# Product/Process Change Notice (PCN)

PCN #: PCN\_WE-STAR-TEC\_20151207\_74271132(S)\_Capacity Increase

Product Affected: 74271132, 74271132S

Already established production line of plastic housing:

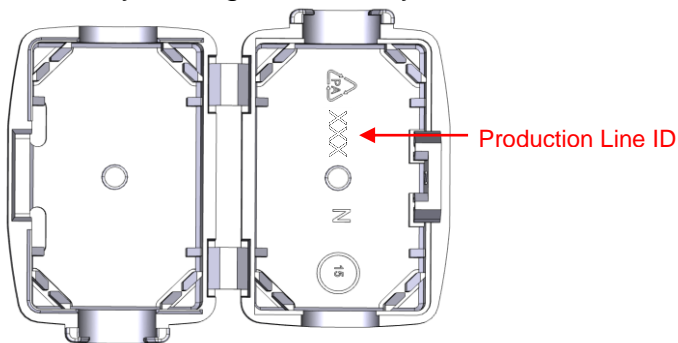
1. Neither electrical nor mechanical properties of the part will be changed.
2. The production lines can be identified by the three digits inside the plastic housing.

Digits: 128

Country of Origin: Germany
